City of Mississauga Department Comments

Date Finalized: 2022-08-24	File(s): A324.22
To: Committee of Adjustment	Ward: 5
From: Committee of Adjustment Coordinator	Meeting date:2022-09-01 1:00:00 PM

Property Address: 3409 Brandon Gate Dr

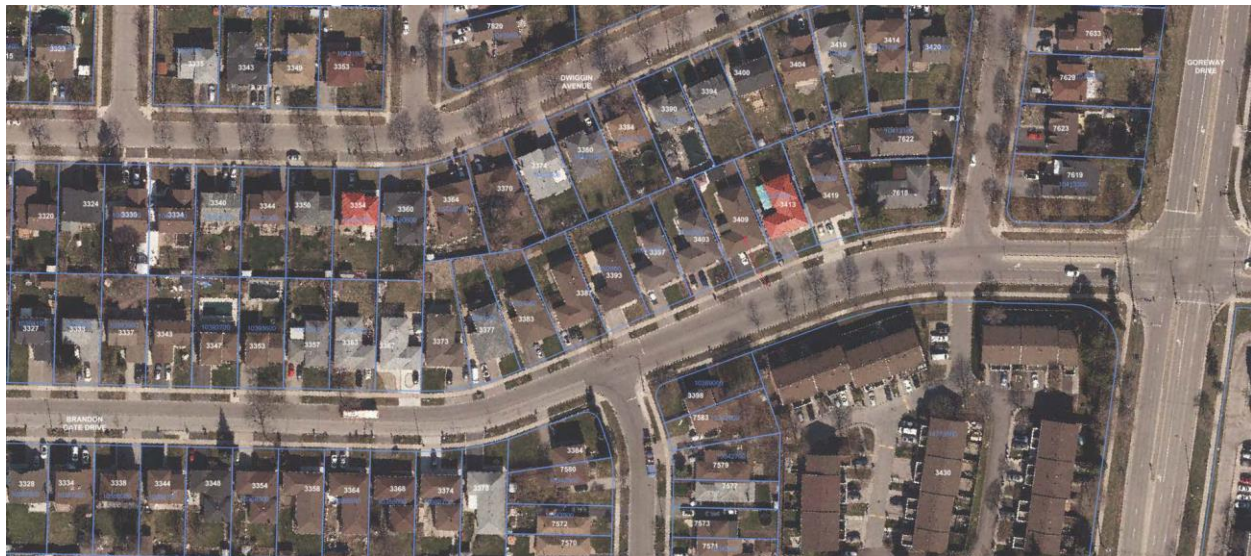
Enclosed are photos which depict the accessory structure and concrete area which also contains a structure. The accessory structure has been equipped with an eavetrough and the downpipe is located such that drainage is directed into the applicant's rear yard which contains a significant size sodded area which should adequately accommodate any drainage.

Acknowledging that this property has a rear to front drainage pattern, should there be any concerns from the abutting neighbour with regards to drainage, then some regrading modifications could easily be made to this property to ensure that any drainage is directed to the front of the property.

With regards to variance#3, we note that a minimum 0.61m setback should typically be maintained, however in this instance, it appears that any drainage impact would only be to the applicant's lands.
